PROJECT/SITE OWNER: Bayside Development Partners II, LLC PROJECT ADDRESS: 600 Block of West Glencoe Place	PROJECT SUMMARY: New mixed occupancy 5 story building
--	---

VILLAGE CODE REVIEW

Date: November 4, 2022
To: Village of Bayside
From: Jackie Mich, AICP; Jeff Maloney; and Dean Proctor, AIA
Re: Building C – Architectural Review Committee Submittal

ONE NORTH - MULTIFAMILY BUILDING C

PARKING PLAN AND CALCULATIONS

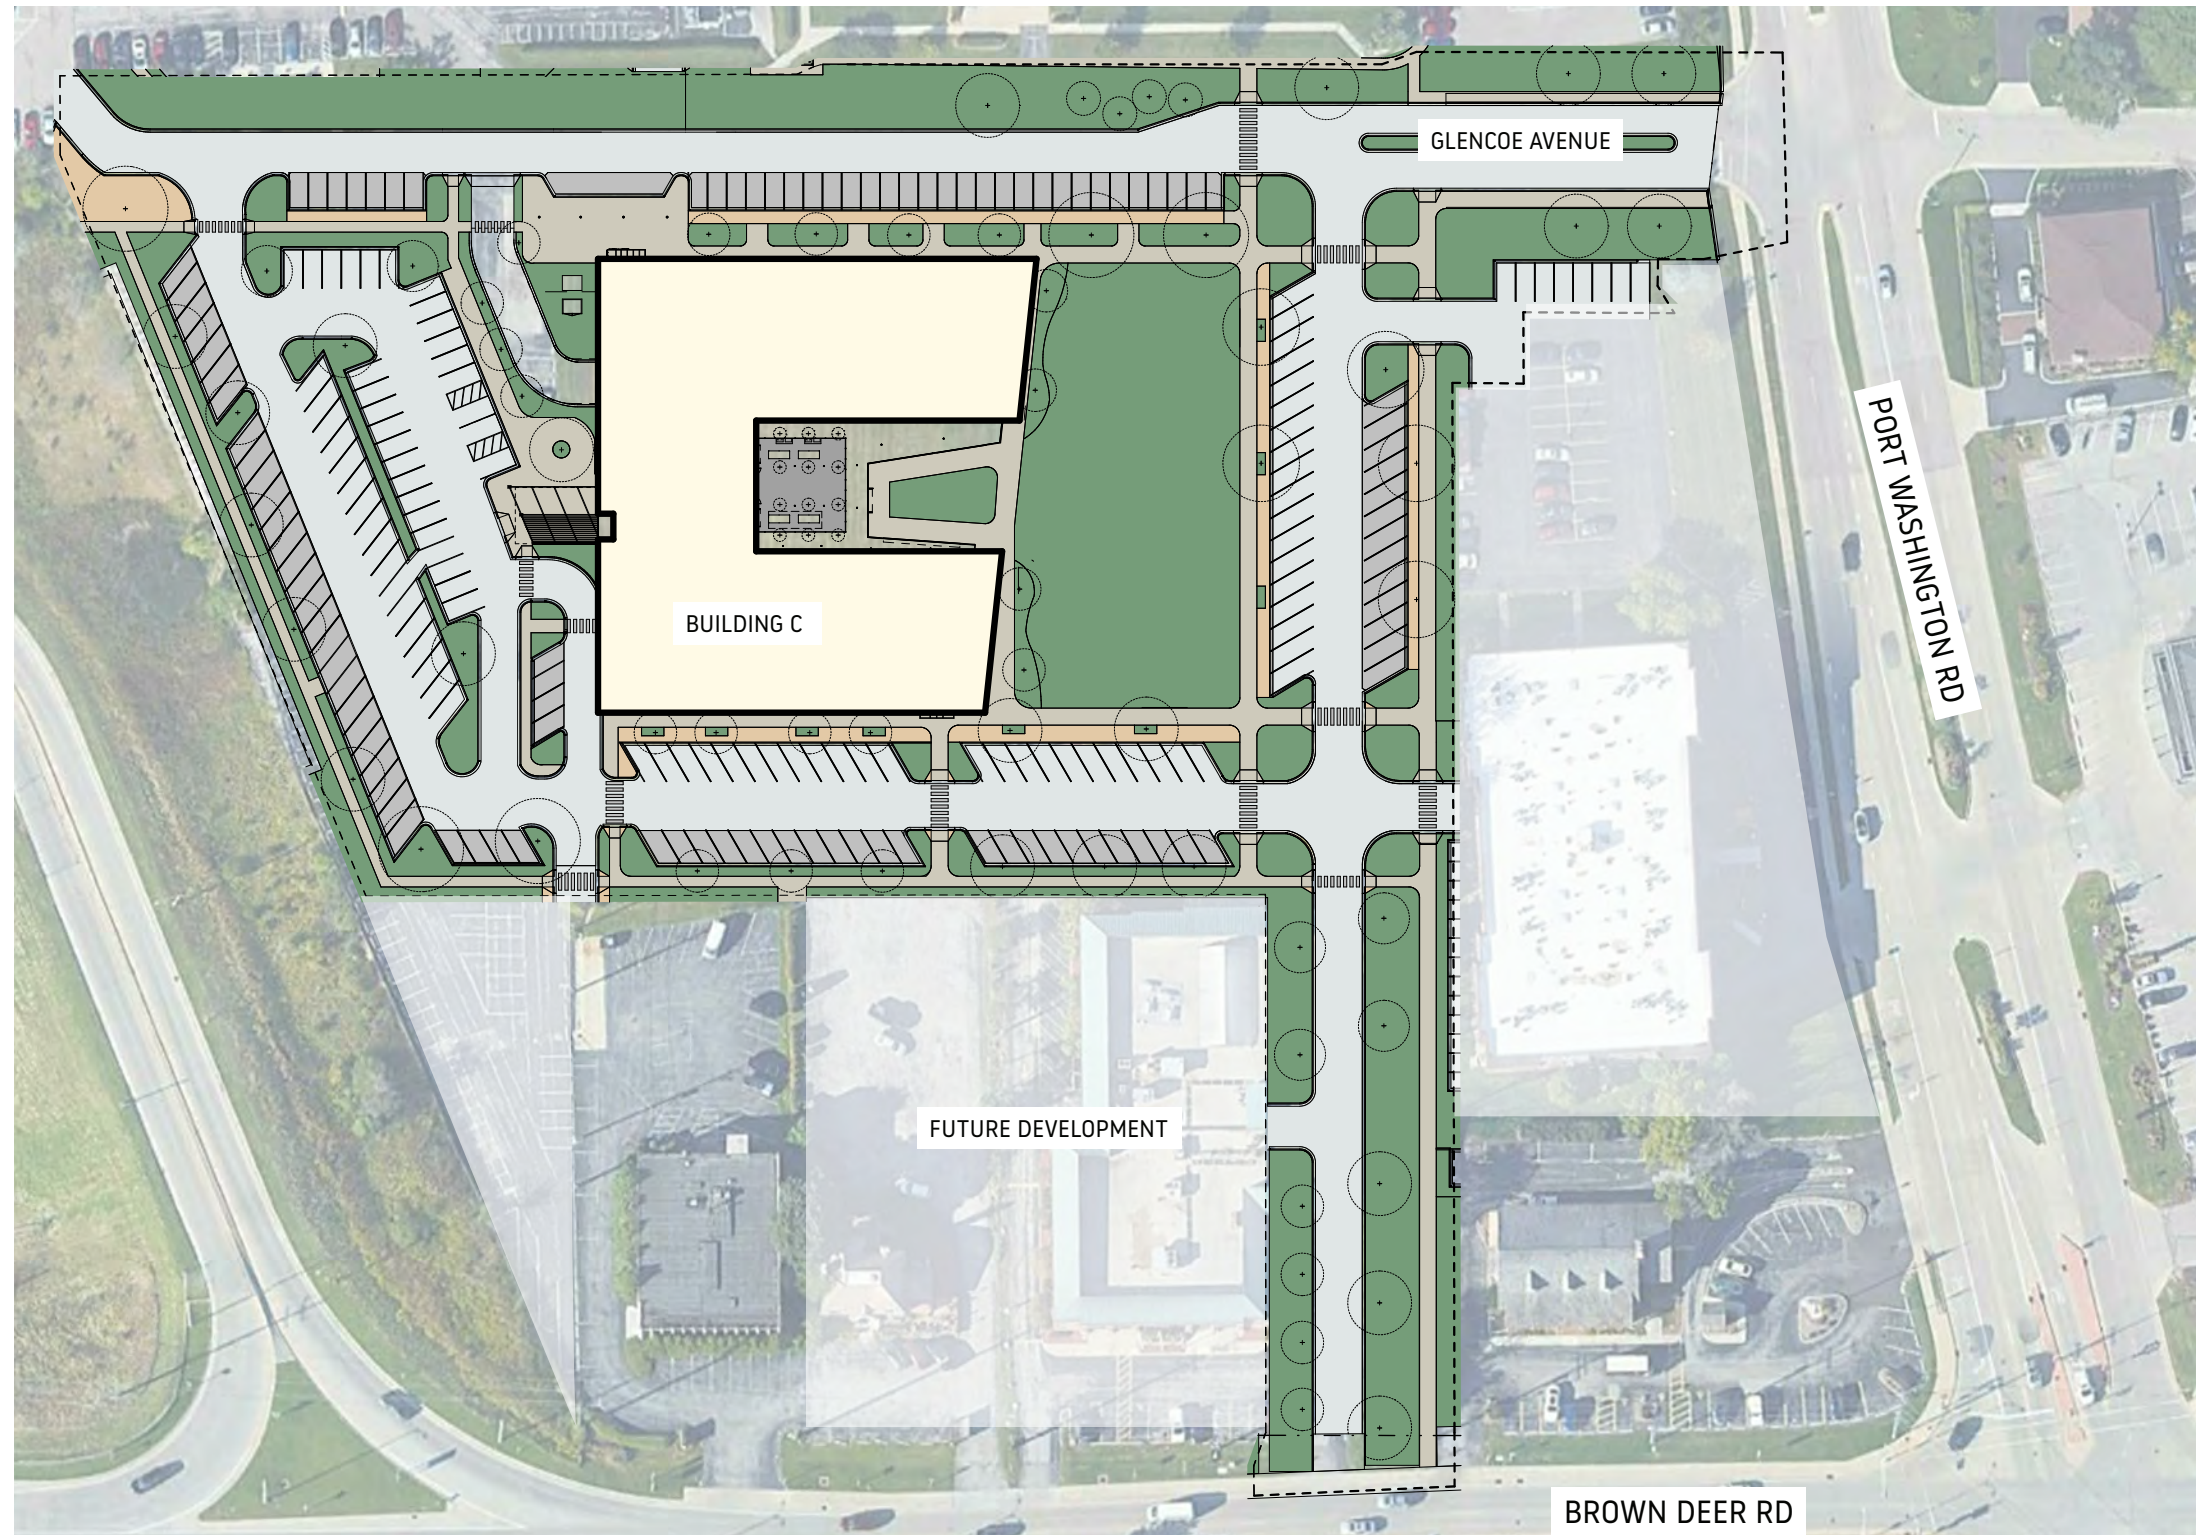
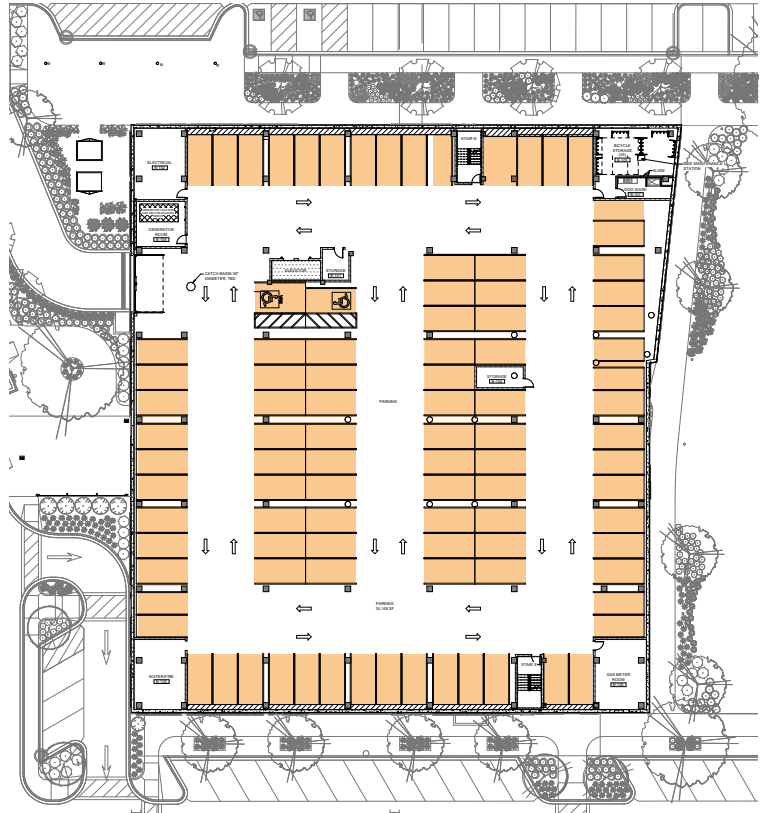
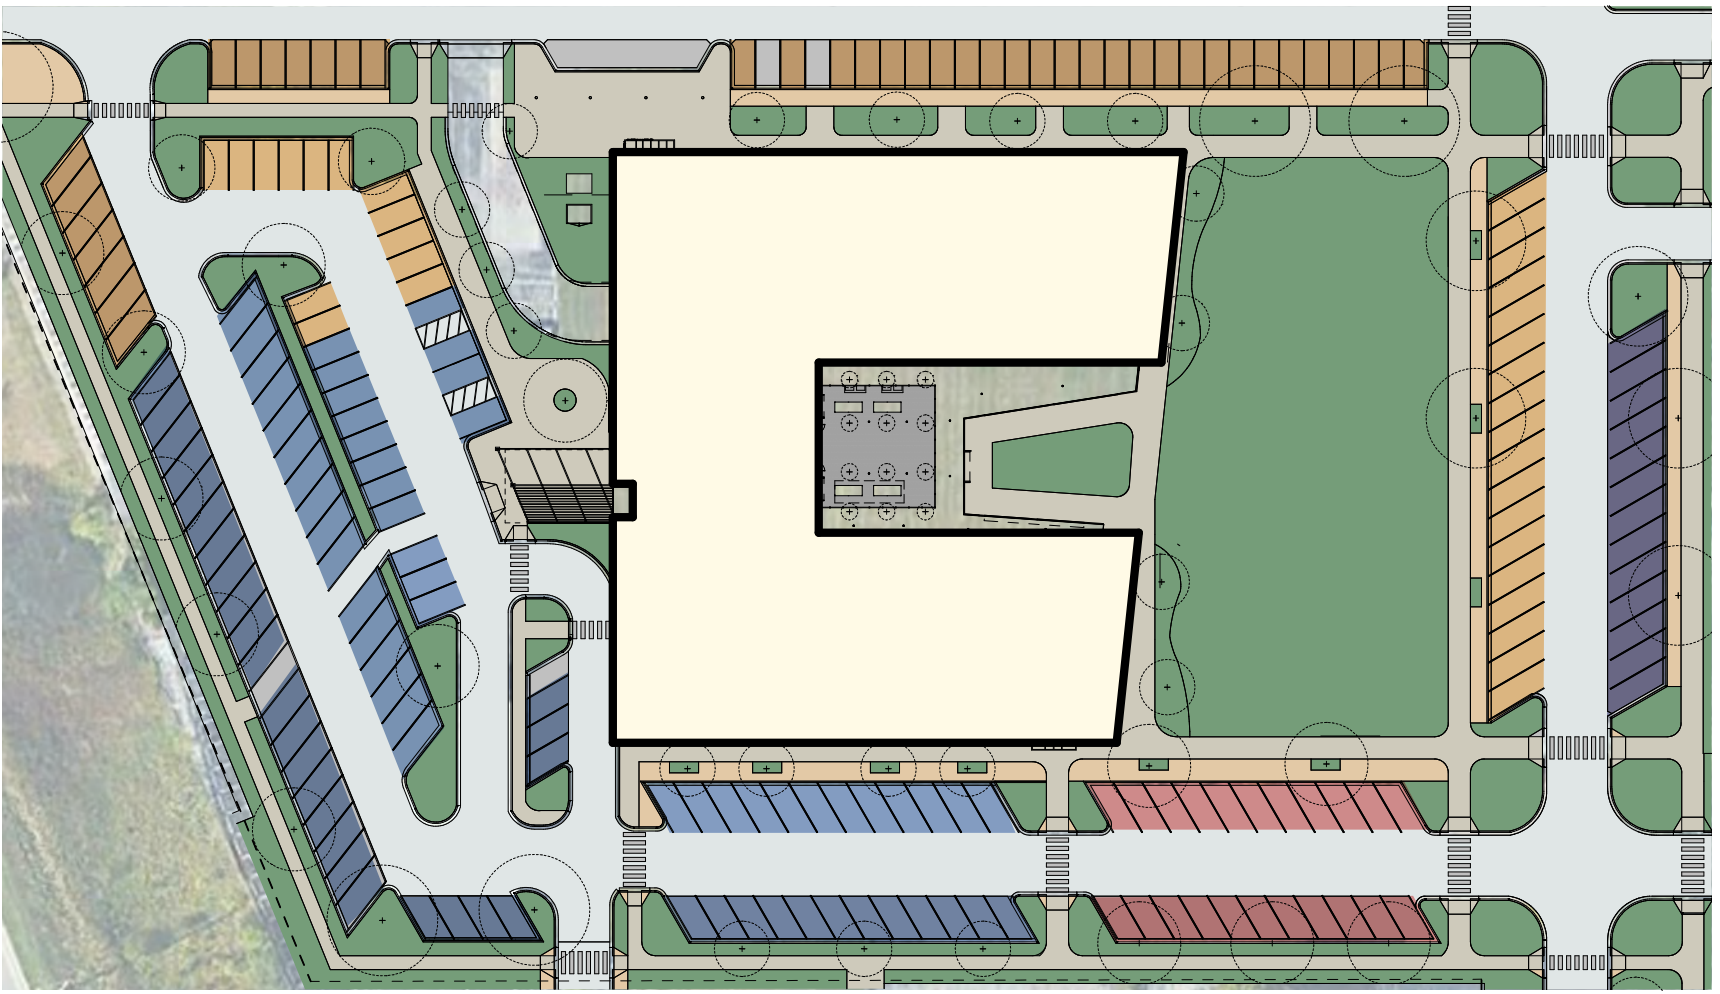
Proposed parking is depicted clearly on the “Parking Plan and Calculations” page of the submittal. Based on the size and number of the uses proposed, a total of 260 parking spaces are required. A total of 285 parking spaces are provided in the project, and therefore the project exceeds minimum parking requirements.

A minimum of 138 parking spaces are required to serve the 98 residential units. Parking requirements are met and exceeded through 98 underground parking spaces plus 71 surface parking spaces, for a total of 169 parking stalls for residents.

Based on square footage alone and assuming a total of 30,500 square feet of general commercial, a minimum of 122 parking spaces are required to serve the first floor uses. Only 116 parking spaces are provided for the first floor uses; however, given that the majority of the first floor will likely be devoted to library space, and given that total parking requirements are met and exceeded, the Plan Commission could consider a modification to the mix of parking permitted.

3. Approve 116 parking spaces for the first floor tenants rather than the 122 required, as the total minimum parking requirements for Building C as a whole are met and exceeded. (Requires approval by Plan Commission)

SITE SIGNAGE PLAN

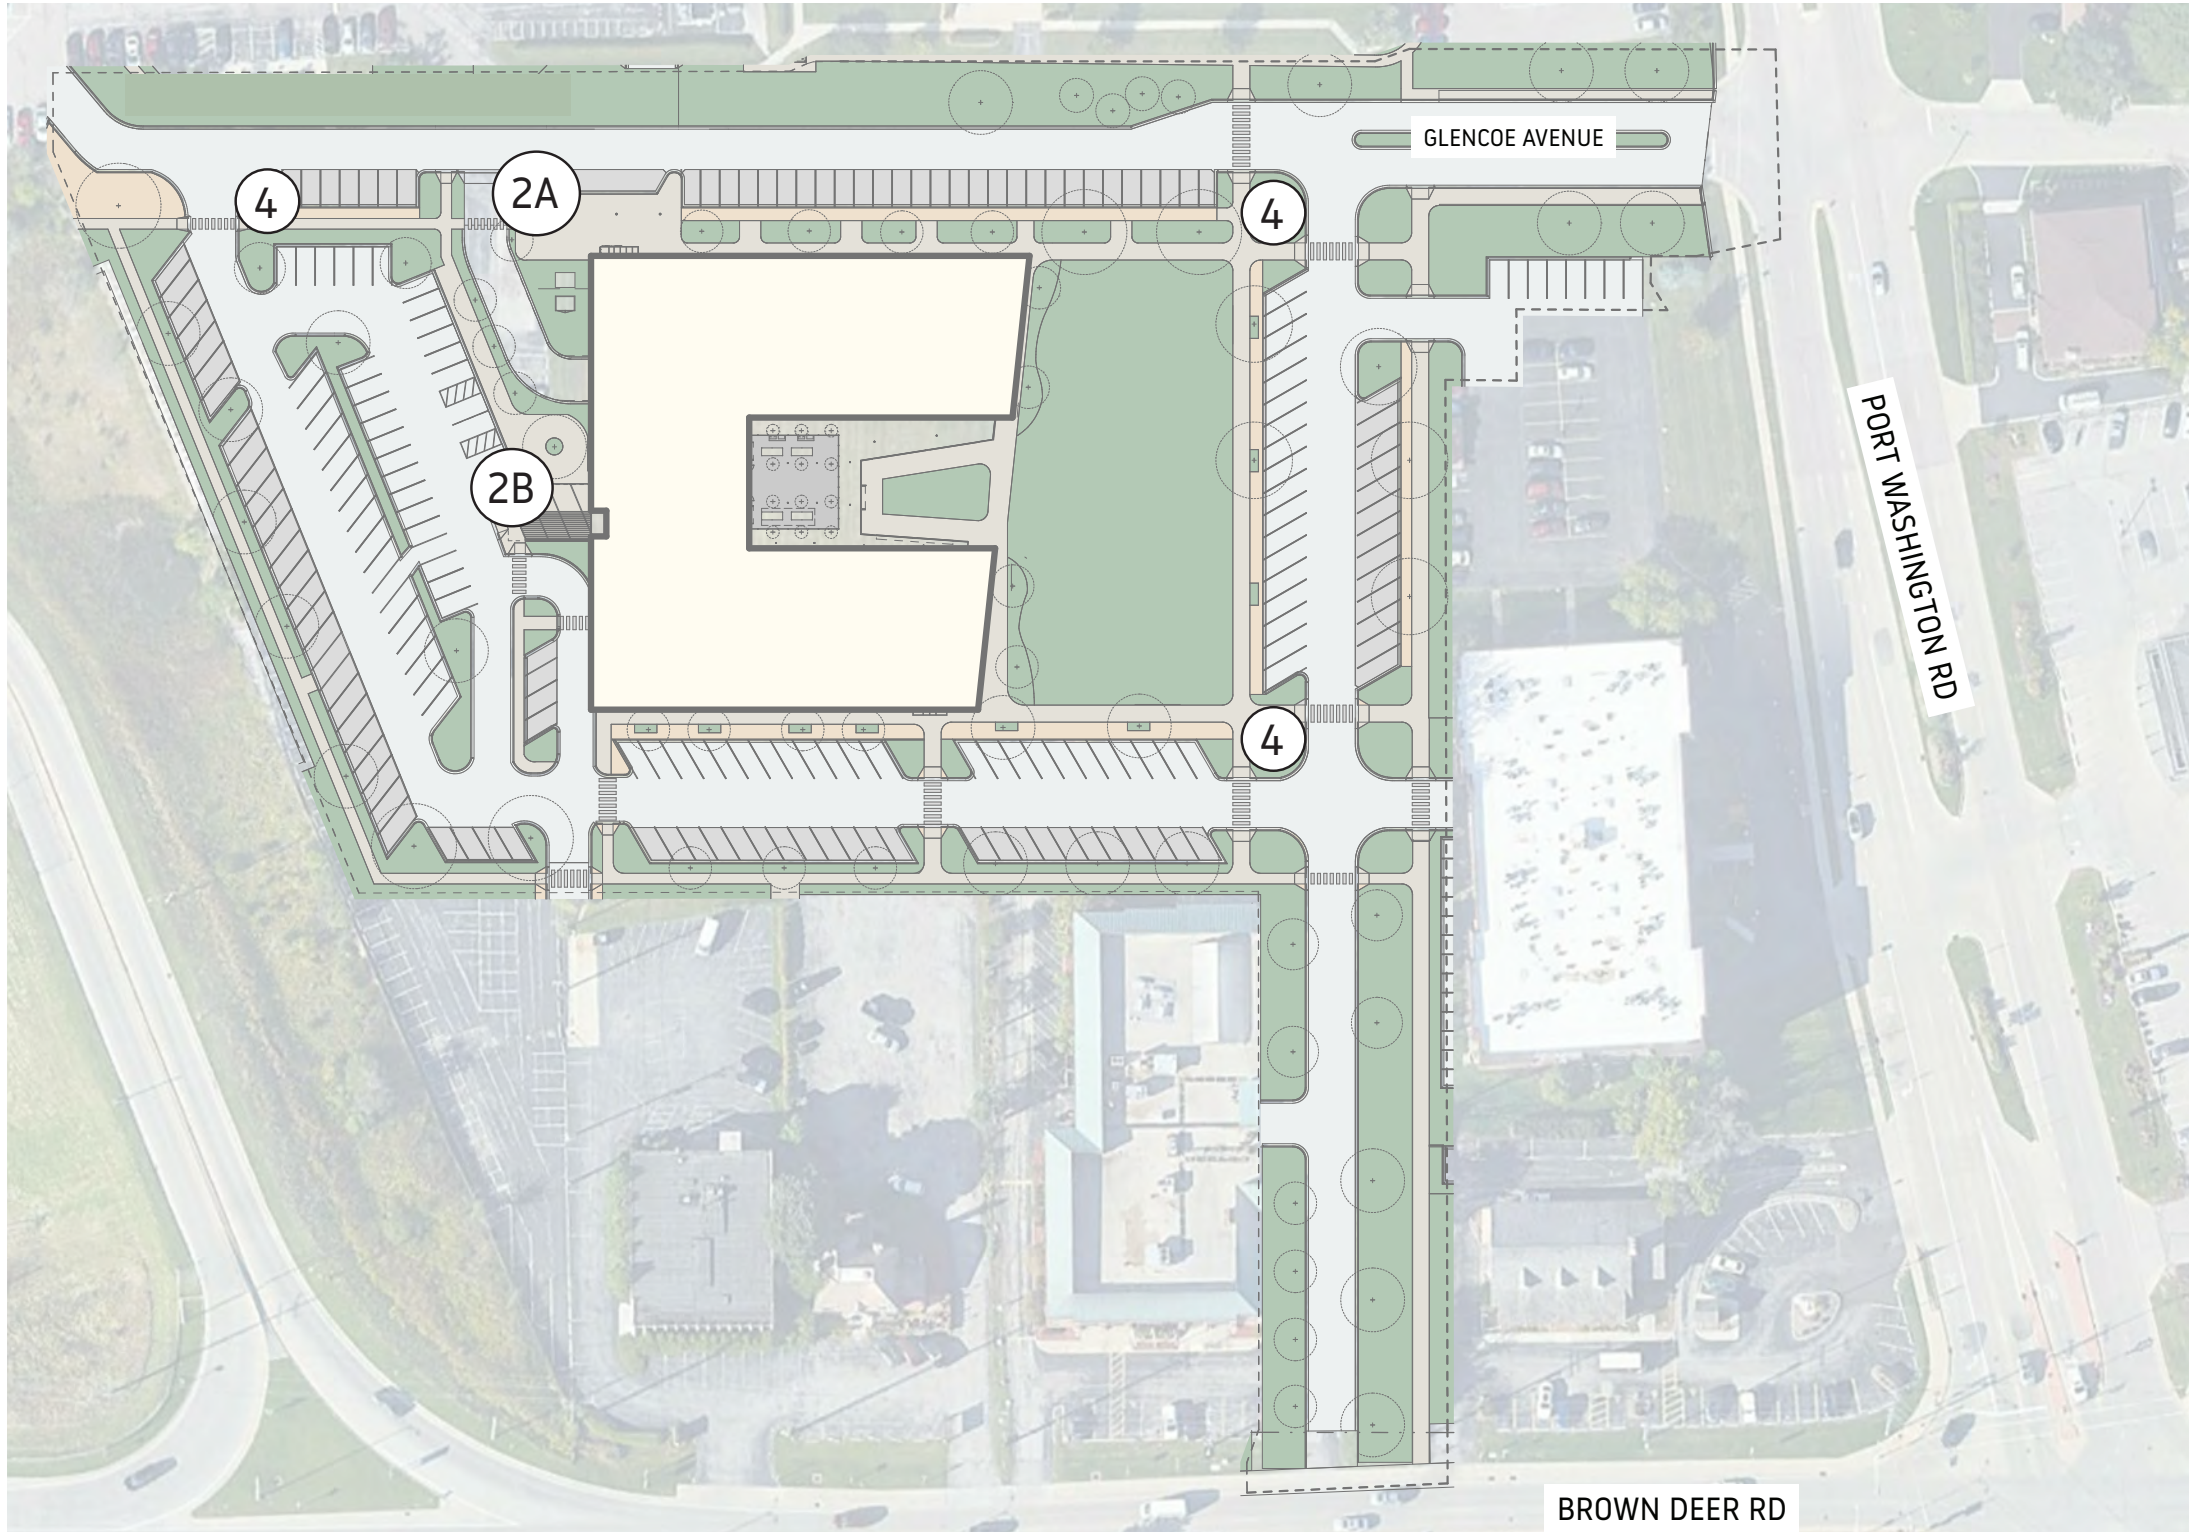
The submitted “Site Signage Plan” identifies two ground monument signs. The first, located along the proposed Glencoe Avenue will be double sided, a maximum of four feet in height, and a maximum of 24 square feet in area on each side. The second, located at the library entrance on the west side of the building, will be double sided, a maximum of six feet in height, and a maximum of 48 square feet in area on each side. Pedestrian-oriented wayfinding signage is proposed at the northwest, northeast, and southeast corners of the site. These will be double-sided and limited four feet in height and eight square feet in area. The proposed site signage is appropriate given the size of the building and surrounding context.
